Under Review Notification

Product #: D169-841

Product Name: AW169 Cable Cutters

D4842-4 LOWER CUTTER BODY RH

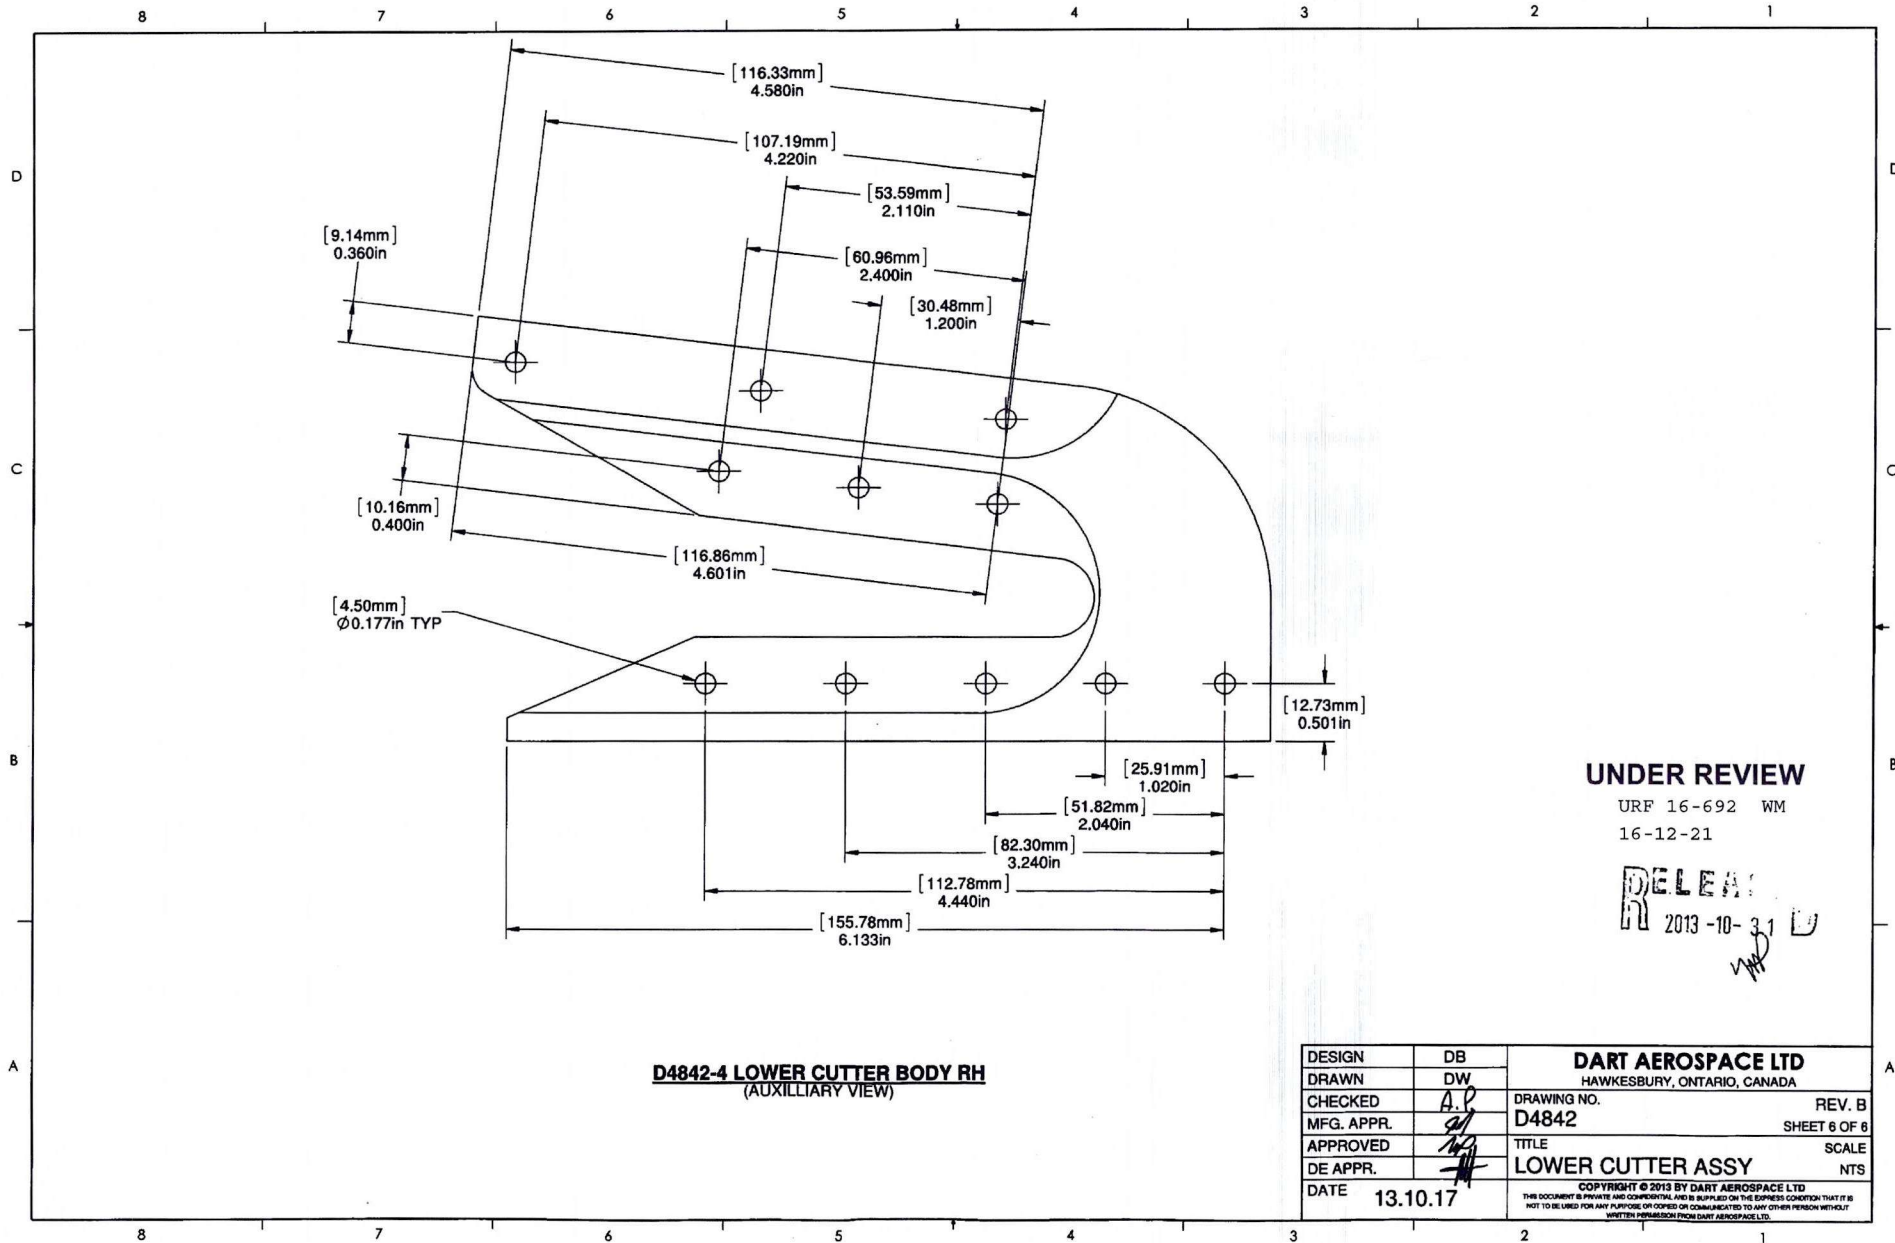
Part Number (D-Part and 9-Digit) (D3535-11/-25, D206-642-143, etc.)	Drawing or Document & Current Affected Revision for each part listed	"Y" or "N" Required for Each Part Do not leave blank							Reserved ECN Log Number	Instructions Relevant to Each Part (including whether CHG #'s will be affected)
		HOLD SHIPMENT	Red Tag/Quarantine Stock	Advise Customers	Stop Production	Re-Work Stock	IPP Under Review	Product Specifications Under Review		
D169-841-015	IIN D169-841, rev D	Y	Y	Y	Y	Y	Y	Y	16-692	
D4842-041	Lower Cutter Assembly	Y	Y	Y	Y	Y	Y	N	16-692	Update part by removing 0.005" from base face
D4842-3	LH Lower Cutter Body	Y	Y	Y	Y	Y	Y	N	16-692	Update part by removing 0.005" from base face
D4842-4	RH Lower Cutter Body	Y	Y	Y	Y	Y	Y	N	16-692	Update part by removing 0.005" from base face

The Lower cable cutter will not install onto the aircraft base. Request by Leonardo for width of base does not match existing product design. Dart asked Leonardo to provide original definition but have not provided it yet. In order to continue shipments, the LH Lower cutter body D4842-3 and RH Lower cutter body D4842-4 that make part of the D4842-041 need to be revised to shave 0.005" off the base interface
 ** Note that this change needs to be communicated to Leonardo by Dart Quality through a Proposal for Change Request and it must be approved by Leonardo prior to implementing **

UNDER REVIEW

URF 16-692 WM
16-12-21
